**COUNTY OF SAN MATEO
PLANNING AND BUILDING DEPARTMENT**

SUBJECT: EXECUTIVE SUMMARY: Consideration of an appeal of the Community Development Director's decision to approve a Grading Permit to allow 590 cubic yards (c.y.) of grading to construct a new residence and basement. The property is located at 900 Menlo Oaks Drive in the unincorporated Menlo Oaks area of San Mateo County.

County File Number: PLN 2017-00262 (Mahadevan)

Tree Protection Plan

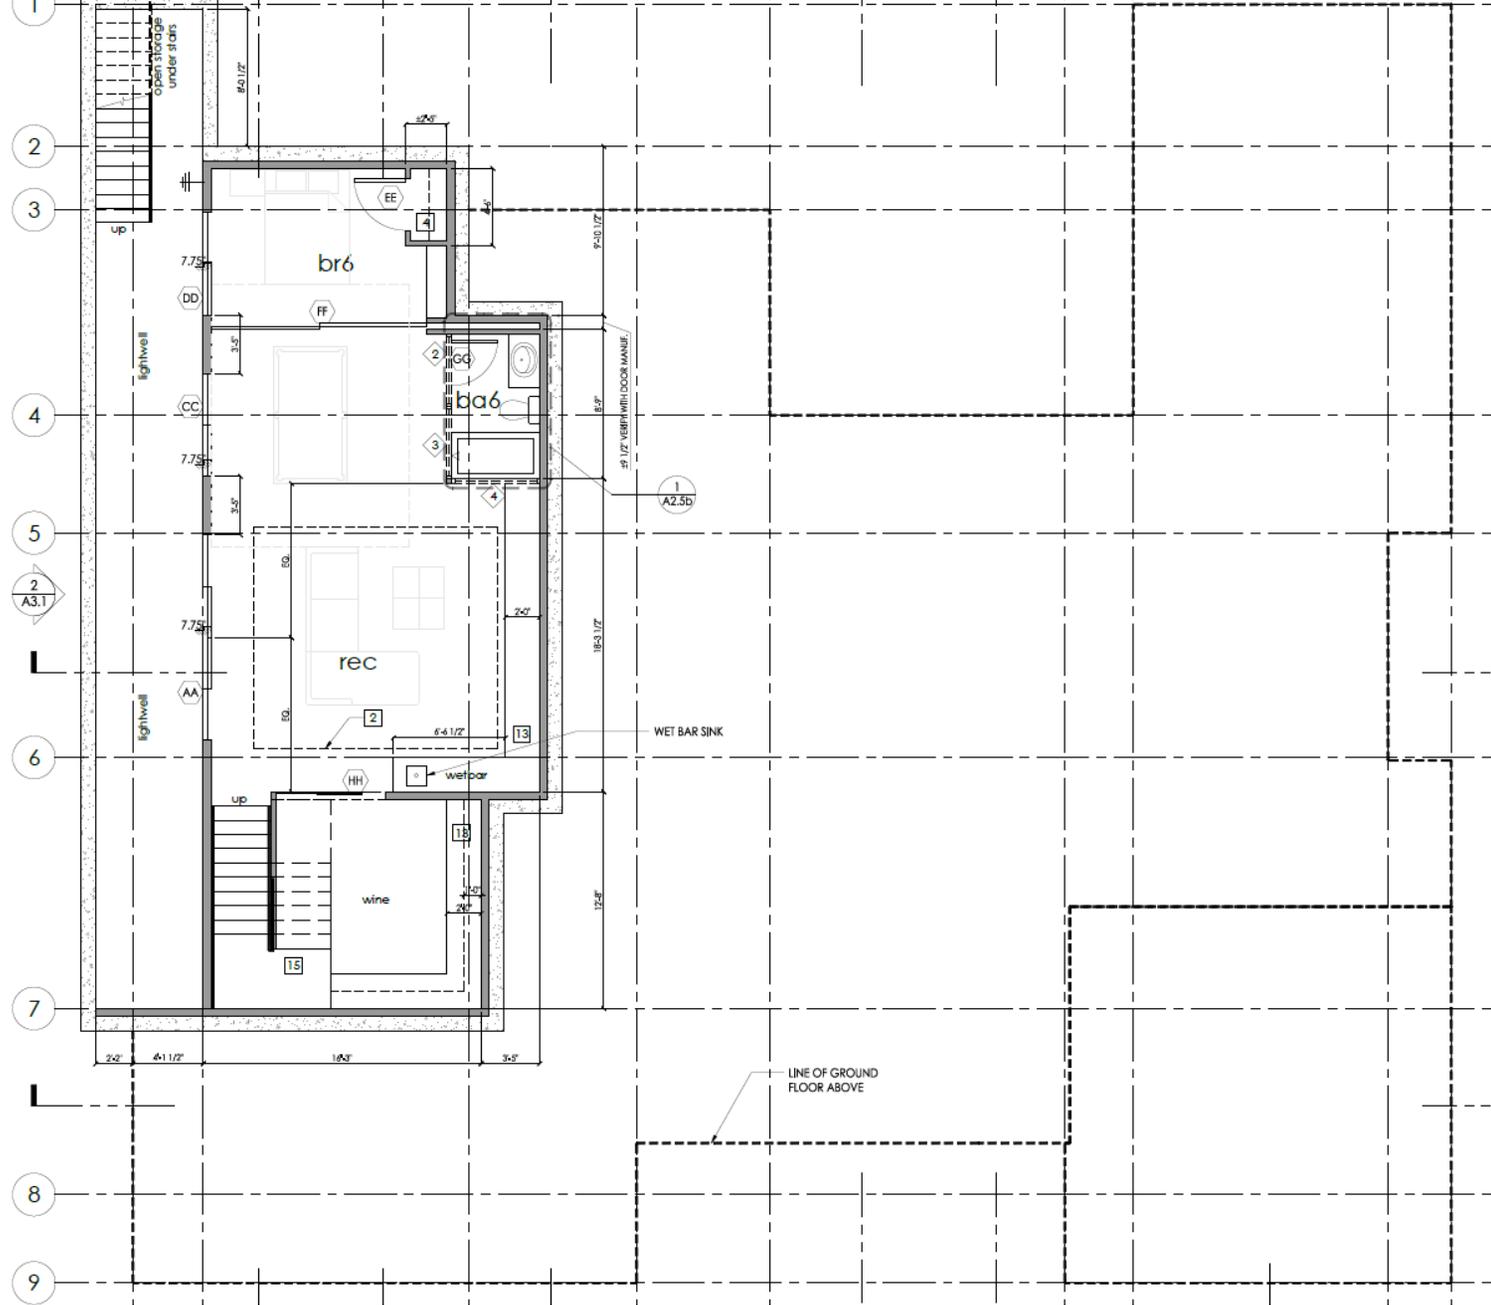
The appellant objects to the total number of significant and non-significant trees proposed for removal. Specifically, the appellant objects to the proposed removal of the 20.7" dbh significant oak tree (tree #24 shown on the Tree Protection Plan) and the removal of the 6.9" dbh non-significant oak tree (tree #25). The appellant states that these oak trees are critical to the tree canopy in the immediate area due to: (1) the large number of non-significant trees proposed for removal, (2) oak tree #25's potential to grow into a mature oak tree, and (3) due to the large number of significant trees removed throughout the Menlo Oaks neighborhood to accommodate various construction projects.

Comment #7: *The loose language of the Tree Protection Plan is concerning. Developer's should be clearly told what is being required of them by using terms such as "shall" instead of "should". This way Developers will not be able to argue that a condition or note on the tree protection plan is merely a suggestion instead of a requirement.*

In response to comments received during the comment period, staff requested a revised arborist report that assessed whether significant oak tree #24 could be preserved and what risks (if any) were associated with preserving the tree. As noted in the revised arborist report dated October 24, 2017 (Attachment I), oak tree #24 is suppressed by adjacent redwood trees #26 and #27 and as a result is

growing at a lean toward the existing house. The report concluded that there is no way to correct the lean of oak tree #24 without removing redwood trees #26 and #27. The report states that if oak tree #24 were to be retained it would need to be pruned yearly to provide a 6-foot vertical fire clearance and to reduce the heavy end weight associated with the tree's lean.

Staff's Response: The attached conditions of approval clearly detail the tree protection measures that must be adhered to. "Shall" is included in the attached conditions of approval in order to ensure that these conditions are not suggestions but requirements.

First Floor Plan

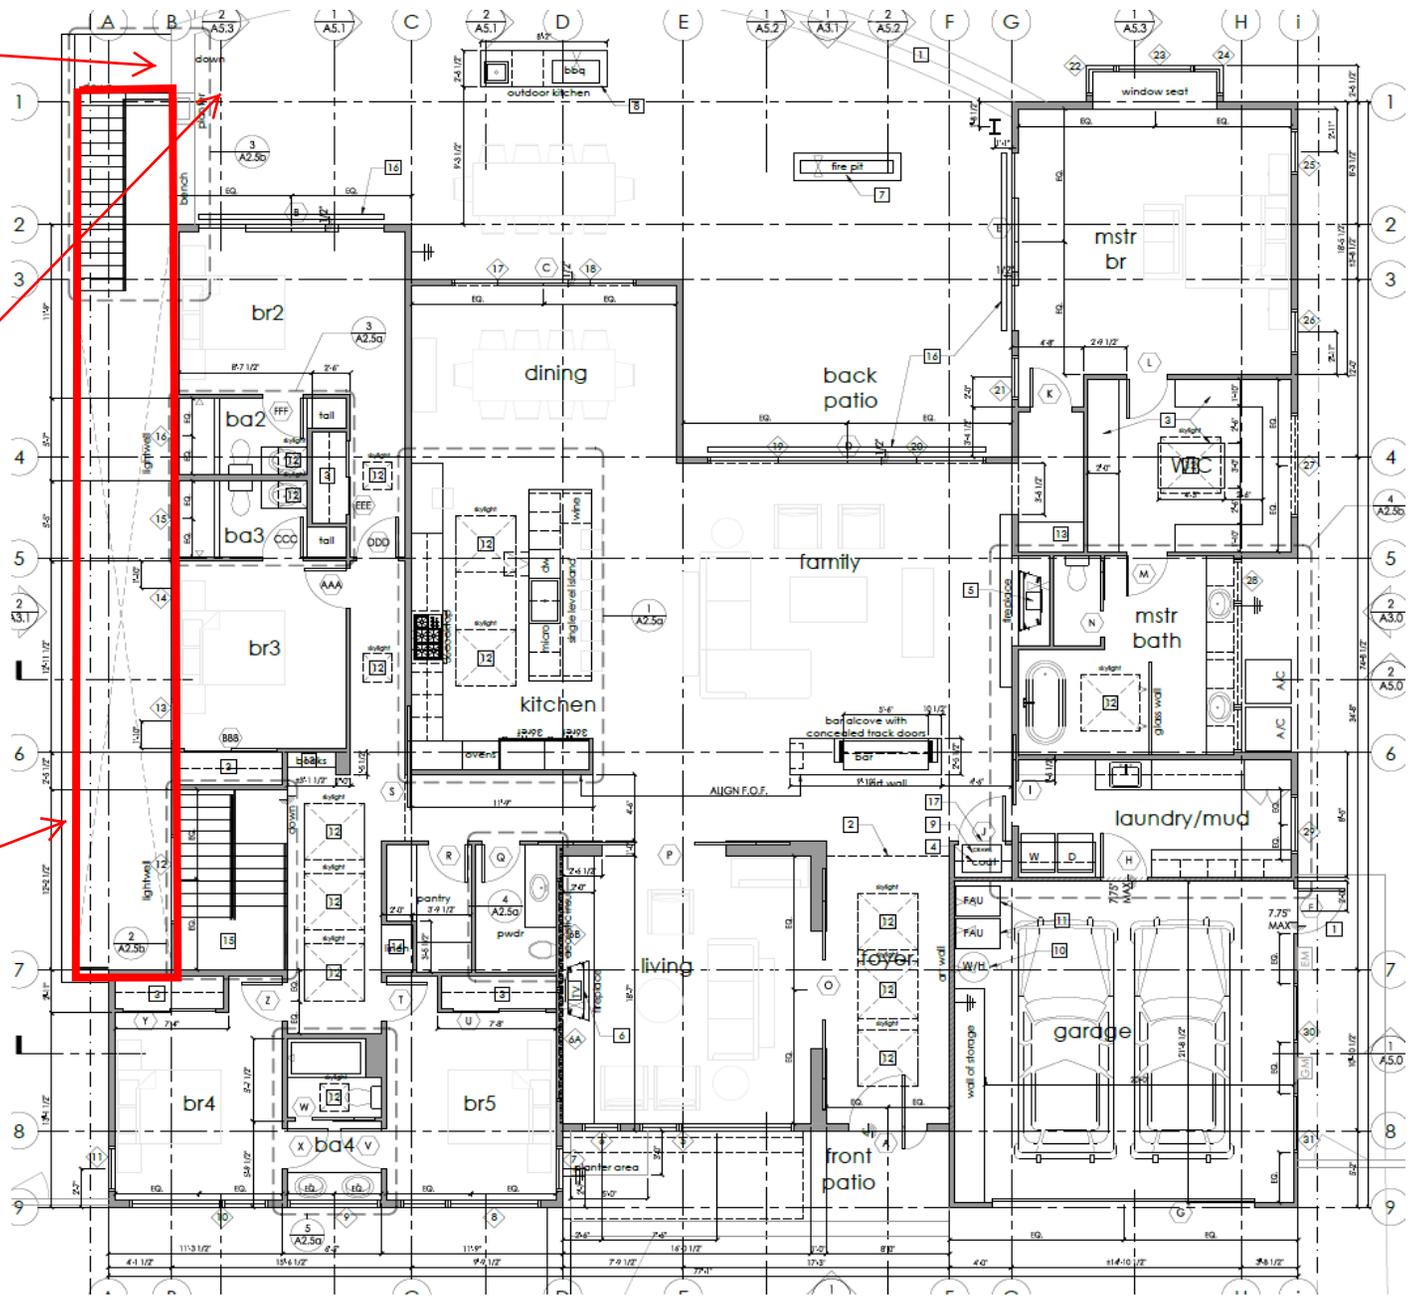
The appellant states that the proposed house can be moved back into the lot to accommodate both the planned construction and the protection and preservation of oak trees #24 and #25.

-- there is an assertion with no analysis or evidence that the house cannot be moved back into the lot sufficiently to accommodate both the planned light well and the existing tree. But a few feet is all that is needed. That is a small compromise considering the large number of other trees to be removed. Alternatives to the removal of protected oak trees should always be considered. That did not happen here.

As proposed, the project would retain the existing driveway, the 89'7" front yard setback of the existing residence, and place the proposed new residence in roughly the same location as the existing residence. Review of the plans submitted to the Planning Department on September 28, 2017, reveal that the placement of the proposed residence is constrained due to the location of the existing U-shaped driveway and the location of several existing significant oak and redwood trees in the rear and front yards of the project parcel. Shifting the proposed structure closer to the front property line to provide at 15-foot buffer zone around significant oak tree #24 would likely require reconfiguration of the existing driveway. Reconfiguring the driveway would impact the 27.9" dbh significant valley oak tree #5 (which is located 10 feet from the corner of the existing residence), three significant neighboring redwood trees located near the front left property line, and may impact the 23.4" dbh significant coast live oak tree #7 located in the middle of the U-shaped driveway.
